Subject: UniStar Nuclear Energy, NRC Docket No. 52-016
Response to Request for Additional Information for the
Calvert Cliffs Nuclear Power Plant, Unit 3,
RAI No. 253, Seismic System Analysis

**RAI 253 Question 03.07.02-46 for the ESWB and EPGB, and
Questions 03.07.02-49, 03.07.02-50 and 03.07.02-51
Seismic System Analysis**

Calvert Cliffs Nuclear Power Plant Unit 3

Figure 35
Floor thickness/Span length ratio for basemat at Elevation -22'-6"

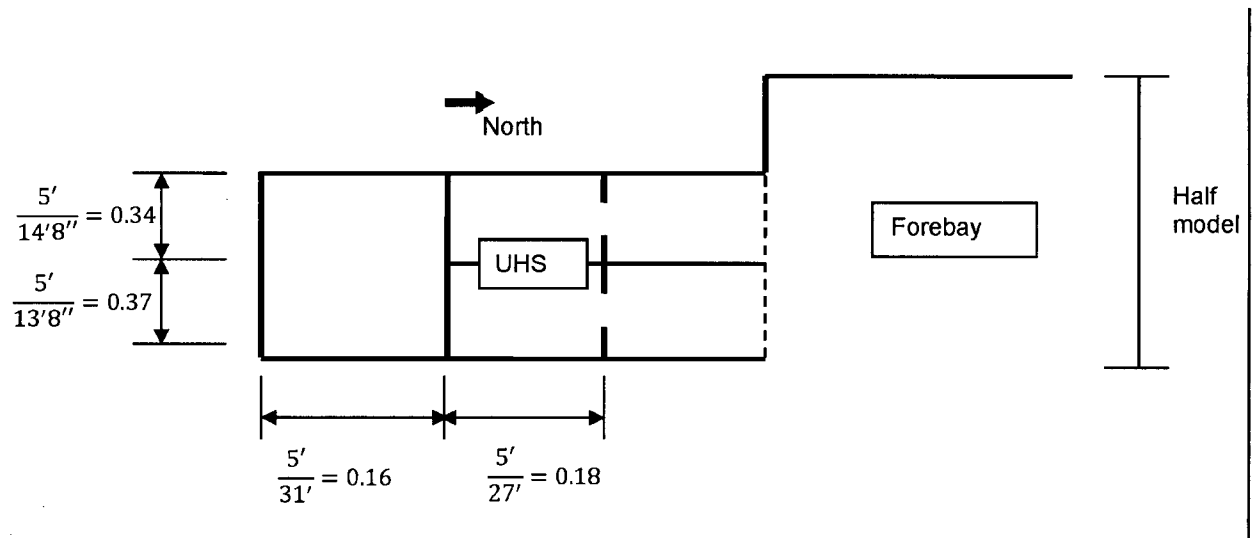
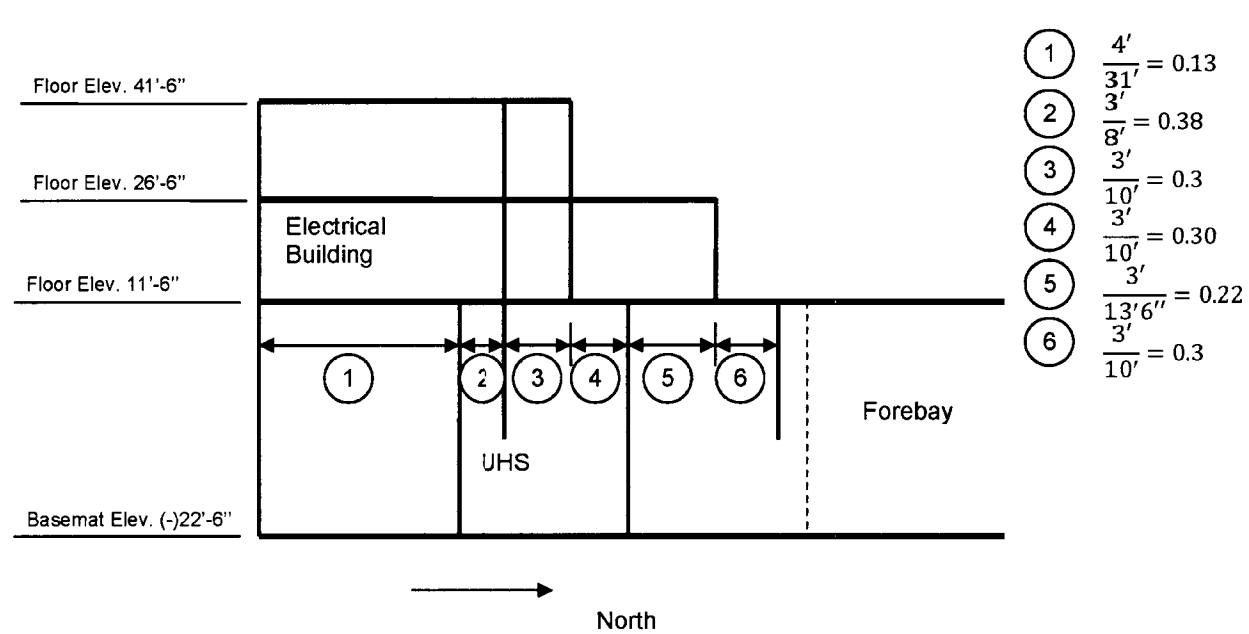
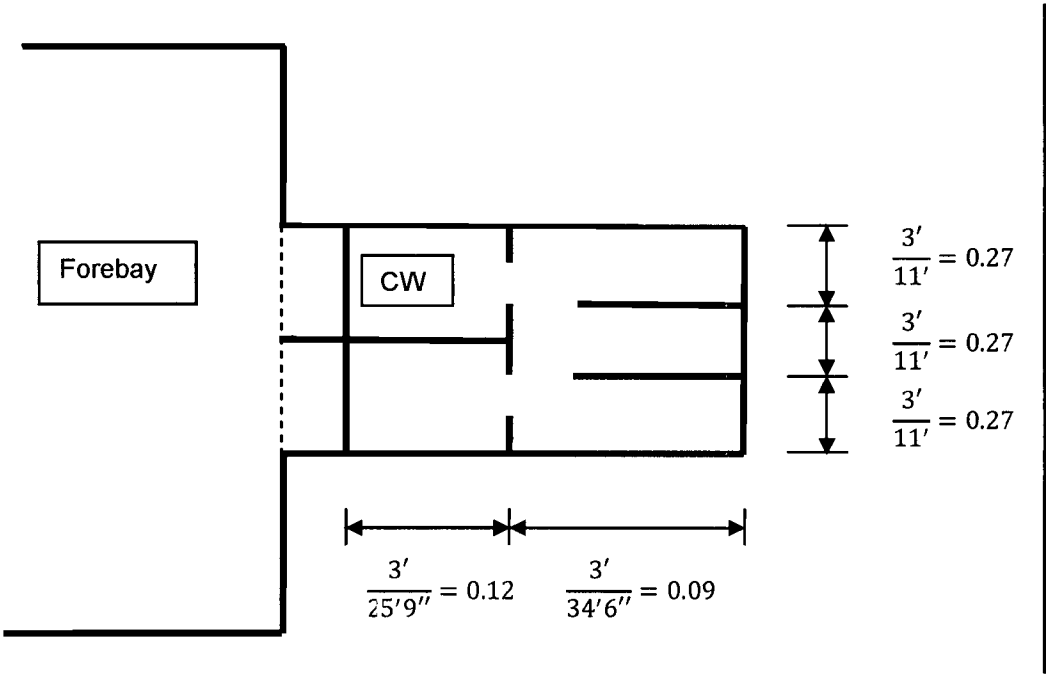
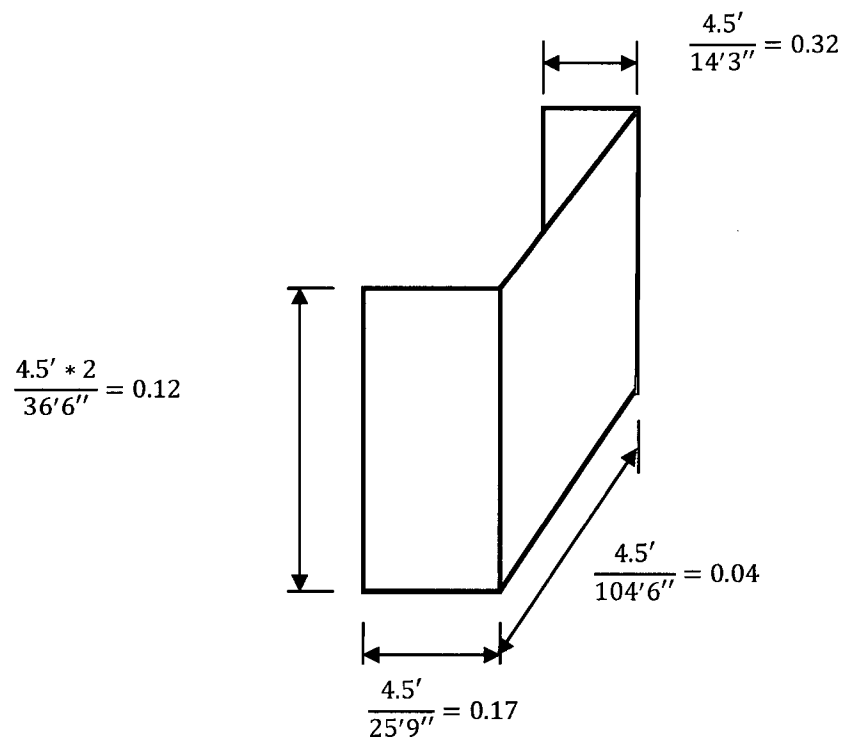
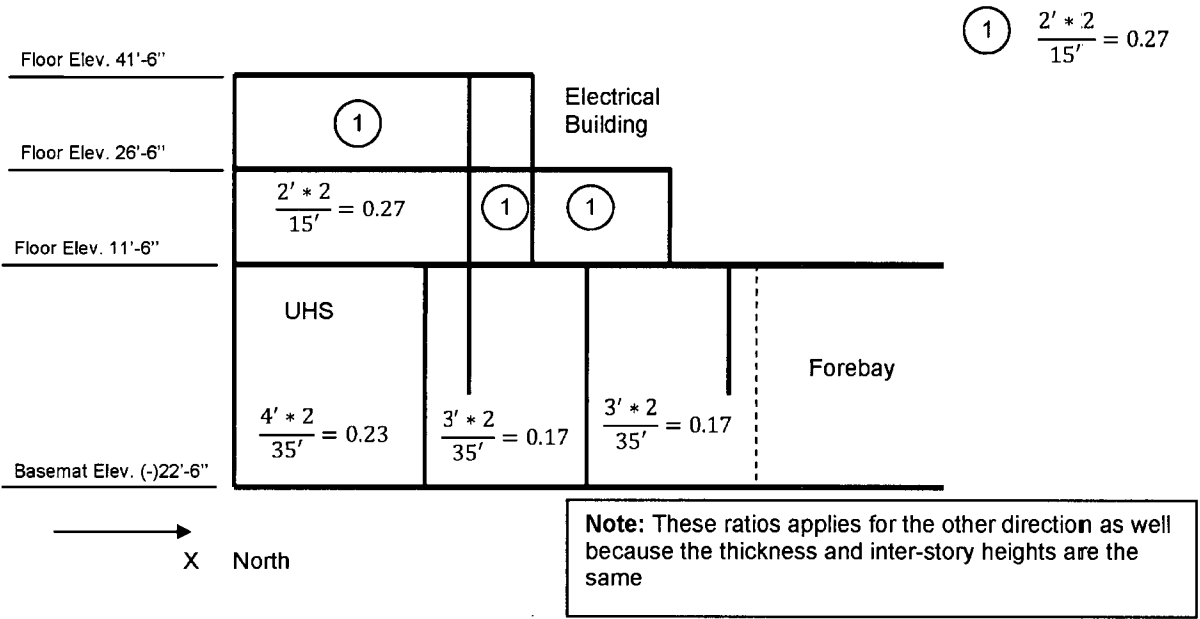
Section 3.7.2.3.2 (page 3-38) indicates that the thick shell element formulation (SHL17) is used in the SASSI SSI calculations for the Common Basemat Intake Structure to account for transverse shear deformation effects as well as in-plane and out-of-plane effects. Given the thickness of the walls and slabs of the structure relative to the spans, it appears that the use of a thick shell element is appropriate. However, the applicant's response indicates that the GTSTRUDL static model made use of a thin shell element (SBHQ6), which does not consider transverse shear effects. The applicant is requested to provide an evaluation of the differences in calculated forces and moments which occur between using the SBHQ6 element vs. using an element that includes shear deformation effects. The use of the SBHQ6 element may produce non-conservative results when determining the distribution of forces and moments within the structure with the result that the structure may be under-designed for Safe Shutdown Earthquake loads.

Note that the spans of the slabs are considered as the distance between inflection points as shown in Figures 35 through 37 for the UHS MWIS and CW. The reason for this selection is that out-plane bending in the slabs is mobilized when the earthquake acts in the vertical direction, whereas the acceleration increases around the center of the slab with inflection points located close to the support provided by the walls.

Bending of the walls about the vertical and horizontal axes was also revised. In the case of bending about the vertical axis, the deformation in the walls occurs along the horizontal direction, so the span of the wall is equal to the distance between the two perpendicular walls

resisting the bending, which is also the span of the slab supported on the wall. Hence, the spans of the walls bending about the vertical axis are equal to the values considered for the slabs shown in Figures 35 through 37. On the other hand, the thickness of any wall in this model is always smaller than the thickness of the slab located at the bottom of the wall. Therefore, the thickness/span ratios shown in Figures 35 through 37 for the slabs bound the values for walls subjected to bending about the vertical axis. The values of thickness/span ratio for the Forebay wall bending about the vertical axis are shown in Figure 38.

For walls bending about the horizontal axis, a conservative approach was followed where the distance between inflection points is considered as half of the story height. These thickness/span ratios are illustrated in Figures 38 and 39 for the Forebay and UHS MWIS, respectively.
